Comments on the Spruce Railroad Trail Expansion and Improvement Environmental Assessment

Clallam County Public Works

October 21, 2011

Survey Notebook Page of Spruce Railroad #1, 1918¹. The “18’ R.B.” refers to the 18-foot width of the top of the subgrade. Railroad ties were laid directly on this subgrade.

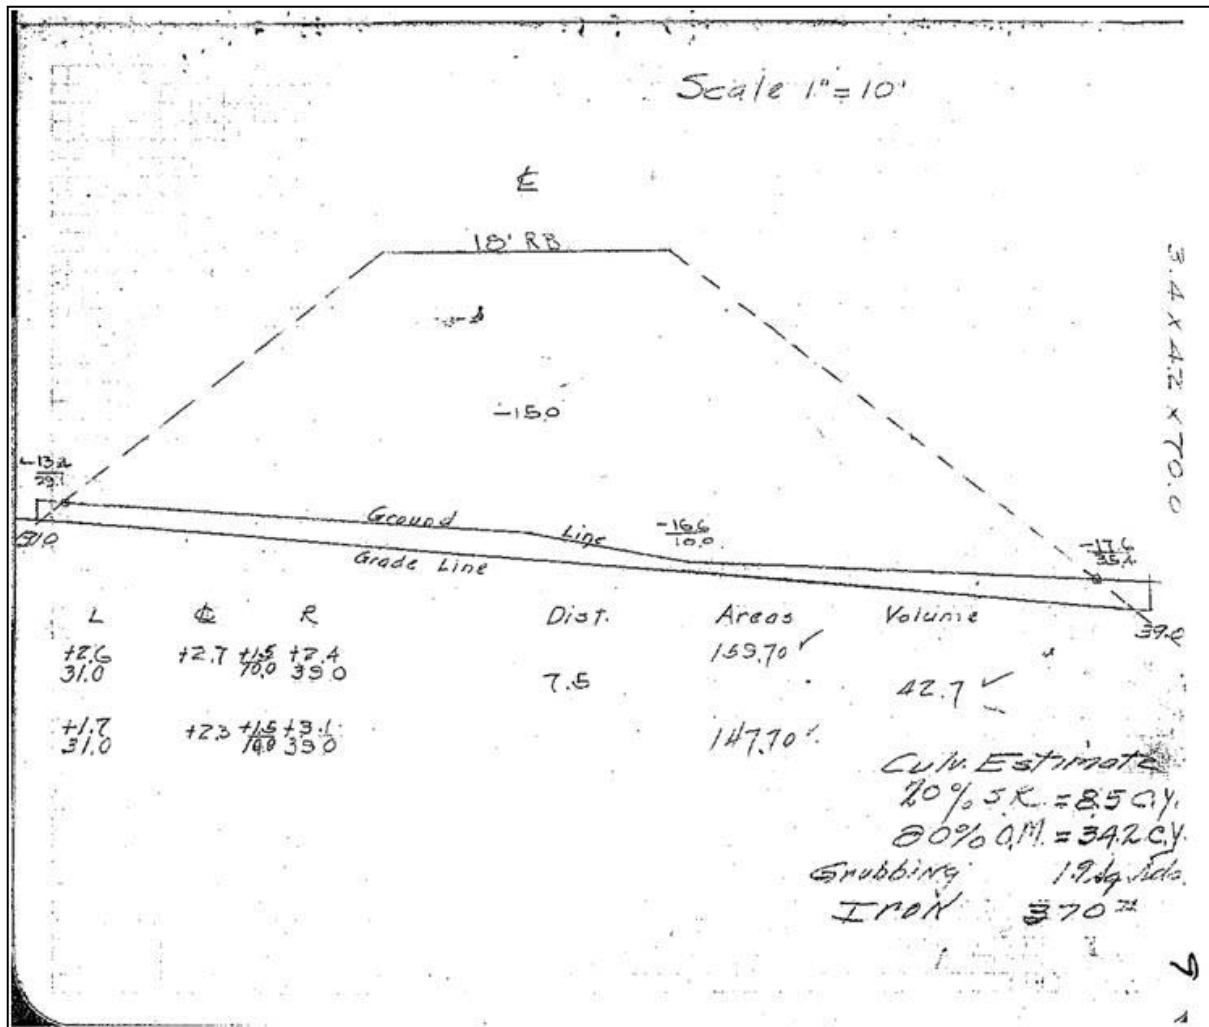
79. Why is no mention given of the review of historic field notebooks undertaken by Rich James and Dave Lasorsa of Clallam County Public Works? This was done during a visit to the Regional Archives, Pacific Alaska Region, Seattle (part of the National Archives and Records Administration) in October, 2010. The purpose of this visit was to review historic documents relating to the construction of the Spruce Railroad #1 during the year 1918. We conducted a detailed study of the original field notebooks used by engineers during the construction of Spruce Railroad #1 in 1918. These showed the typical design elements relating to railroad construction: stations, depths of cuts/fills, calculations of areas and cubic yards for excavation and embankments, and culvert

placement. These notebooks were compiled **as the work was being done**, and were more correctly termed as-built drawings. These calculations and drawings were critical for payment to the subcontractors. Dozens of cross sections and profiles were reviewed. **In all cases, theses showed the top of the roadbed (subgrade) to be at least 16 feet, and most often 18 feet.** Even at difficult near-vertical rock faces such as the Lyre River Canyon, the width of this subgrade was at least 16 feet. Historic photos taken during construction reinforce this width.

Survey Notebook Page of Spruce Railroad #1, 1918.² Taken in Lyre River Canyon, showing slopes of “3/4- 1 R.B. 18’ ” Even at slopes less than 1:1, an 18-foot roadbed width was maintained.

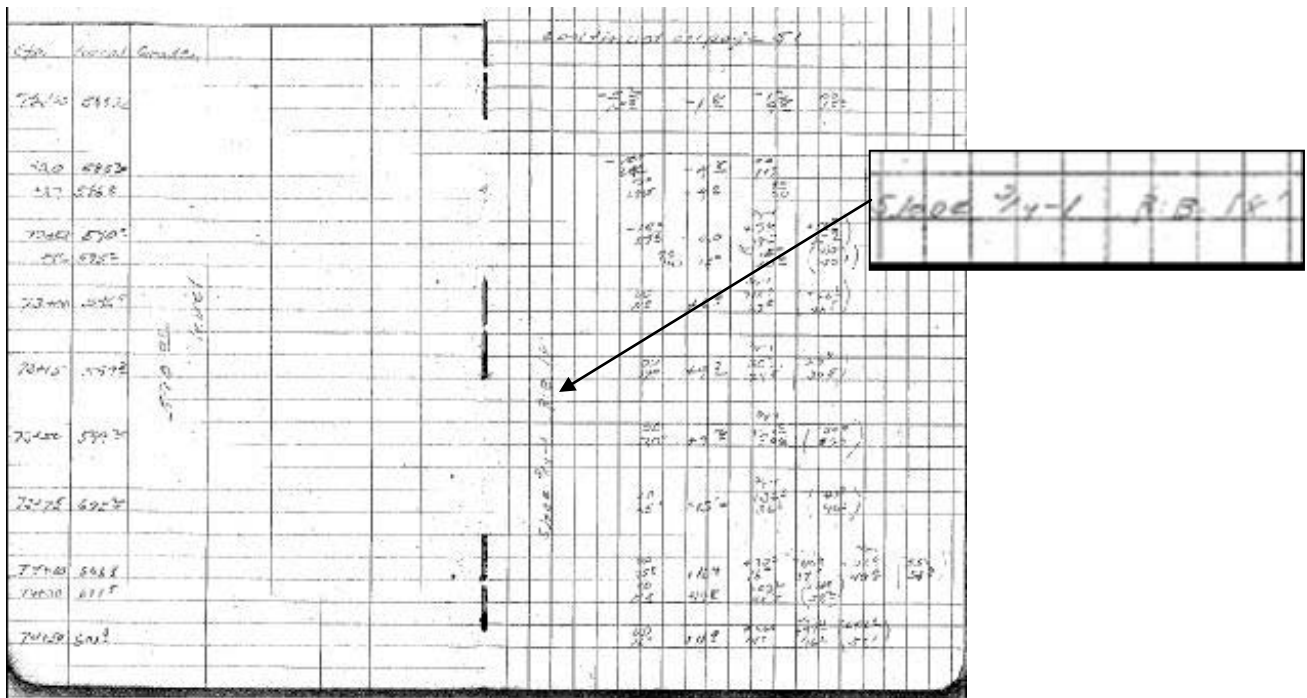
82. These discussions of grade dimensions are critically important if one is to establish a “baseline for evaluating environment consequences as stated on page 123 of the EA. Without an understanding of the original width and dimensions of the grade, any analysis of impacts to this cultural resource is meaningless.
